Origination Form

Proposed Revisions to a Standard Plans Index

Originator:	Meyer, Ronald	Index Number:	700-120
Date:	6/5/2024 1:55:54 PM	Sheet Number(s):	7, 8, 10, 13, 14
E-mail:	Ronald.Meyer@dot.state.fl.us	Index Title:	ENHANCED HIGHWAY SIGNING ASSEMBLIES

ROADSIDE SIGN ASSEMBLY-11

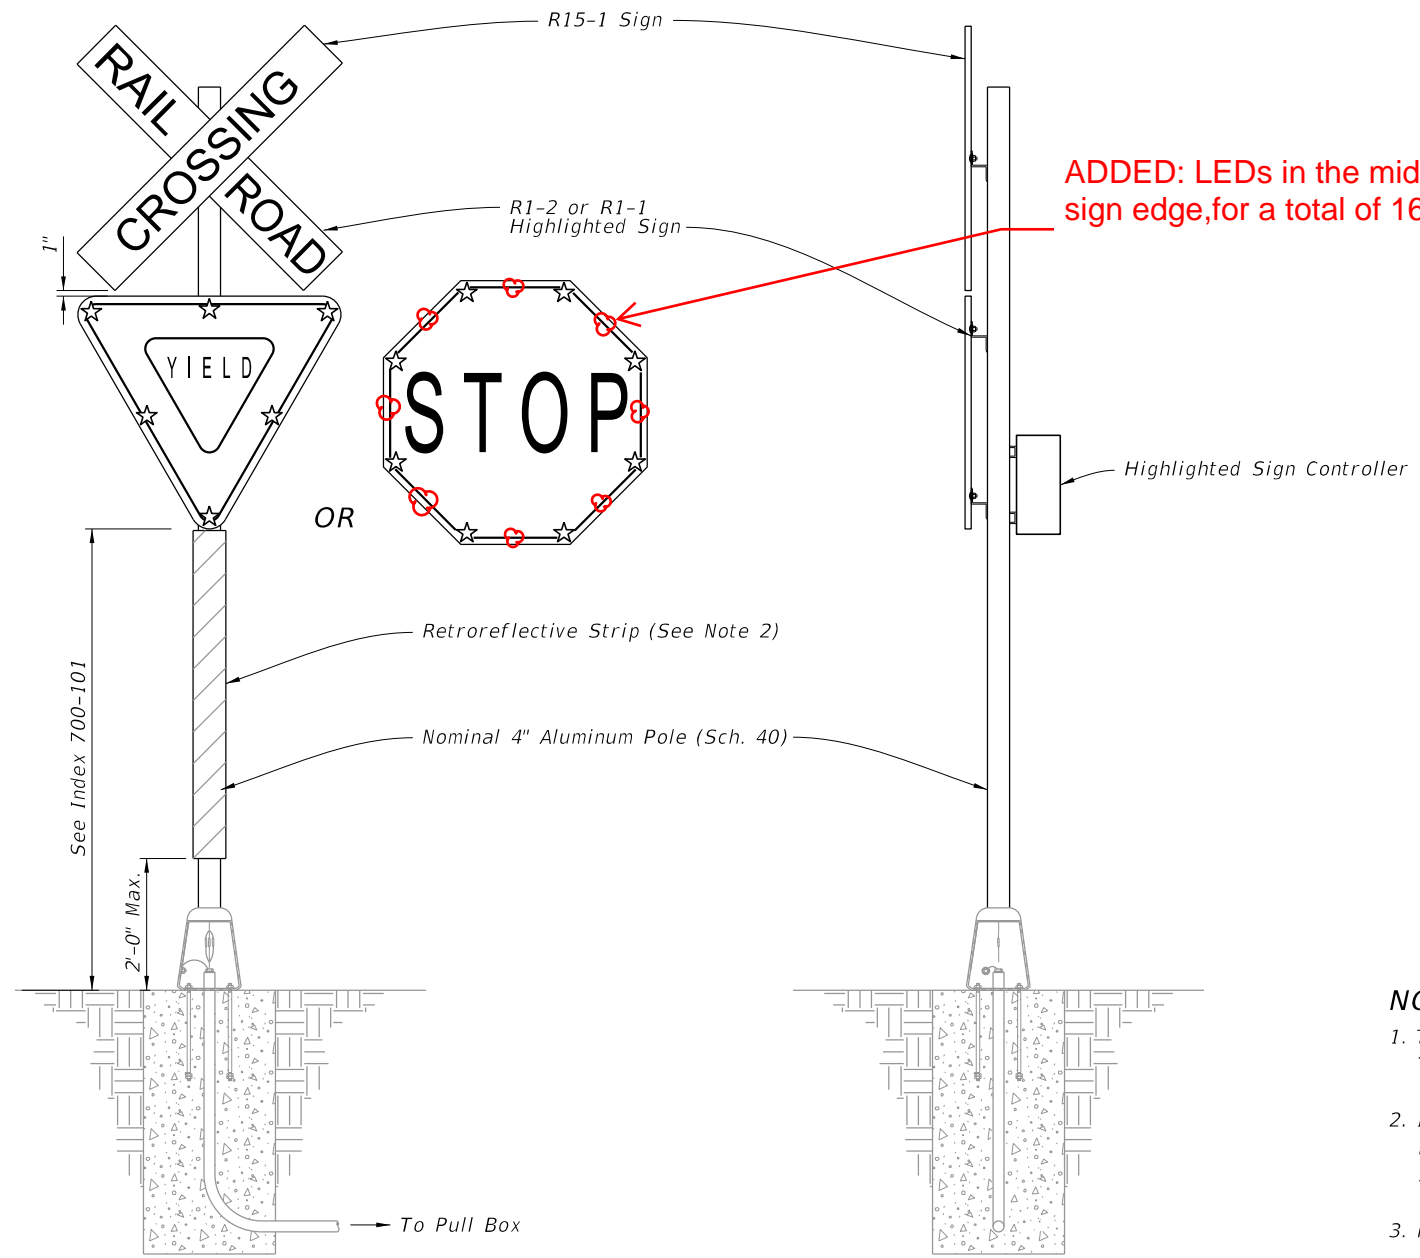
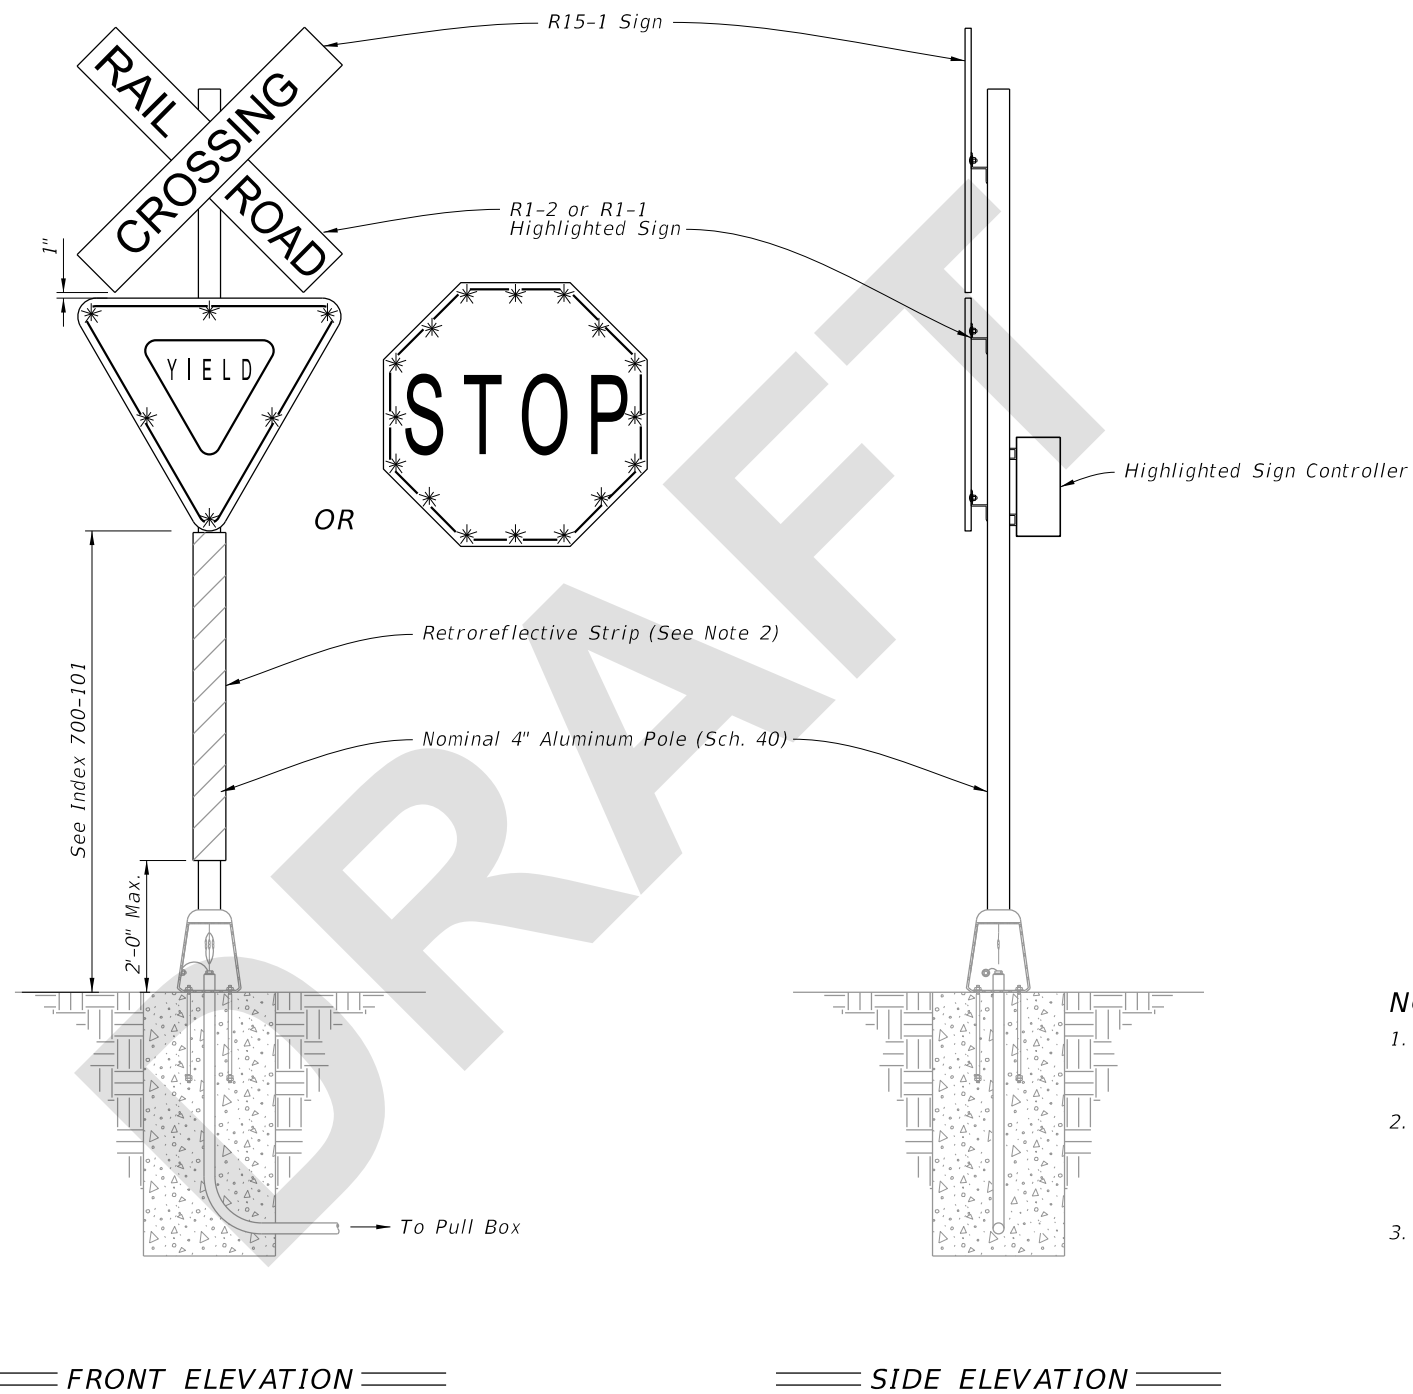
Sheet 10, 13, and 14: Where LED units are used along the edge of a sign, at least one LED unit shall be placed along each edge of the sign, in addition to one LED unit at each corner of the sign, so that the distinct outline of the sign shape is recognized under nighttime viewing conditions. The LED units along each side of the sign shall be spaced approximately equidistantly. For a circular sign shape, the number of LED units shall clearly form the appearance of a circle and not be perceived as some other shape.

ADDED: LEDs in the middle of each sign edge, for a total of 16 LEDs.
